Keith Midson
Midson Traffic Pty Ltd
18 Earl Street
Sandy Bay TAS 7005
0437 366 040

11 January 2017

134 HOBART ROAD, KINGS MEADOWS – SIGNAGE ASSESSMENT

Figure 1 Signage Location & Line of Sight

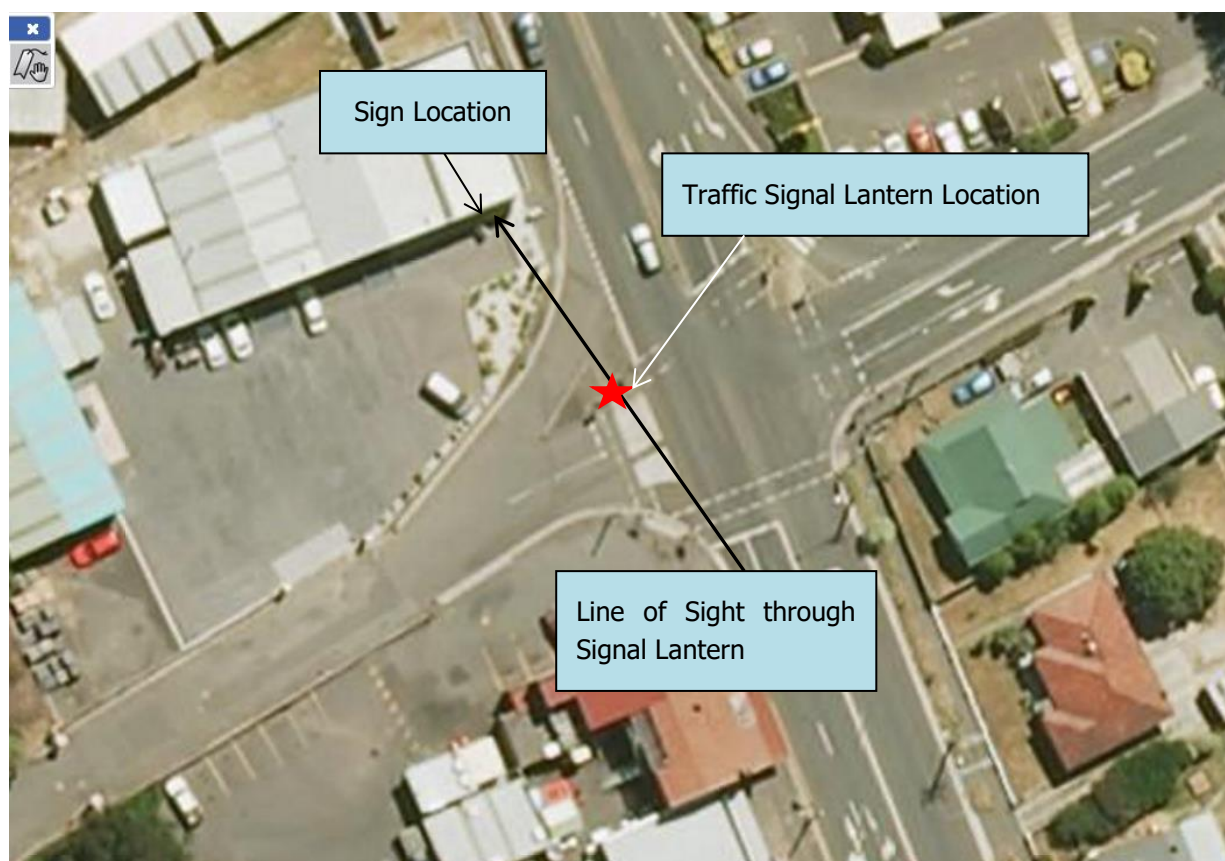
- The sign is proposed to be located in a location where there is a relatively high amount of competing advertising signage and other visual clutter.
- The sign is located immediately behind the traffic signal lantern on the northwest corner of the intersection (for northbound traffic). This location is within direct line of site for motorists to confuse the advertising sign with the operation of the traffic signals (background clutter behind signals – refer to Figure 1).

On the northbound approach to the intersection of Opossum Road on Hobart Road, the advertising sign is located approximately 20 metres behind but within the general line of sight through the intersection as shown in Figure 1.

Whilst the proposed signage is placed behind the traffic signals (considered safer than behind signals), it is located in a cluttered urban environment with a crash history that is of concern. On this basis, it may be reasonable to recommend refusal on the grounds of safety.

On this basis, it is recommended that a dwell time of 30 seconds be a condition of approval. This is consistent with Victorian requirements (noting that Tasmania has adopted many road design requirements from Victoria).

The developer has indicated that the illumination will be >6000 nits of brightness. This is considered too bright and may reduce the effectiveness of the traffic signal lantern located immediately in front of the sign. Typical maximum levels of 2,900 nits are recommended in shopping and commercial areas.

- Dwell time – 30 seconds
- Transition time – instantaneous
- Luminance – 2,900 nits
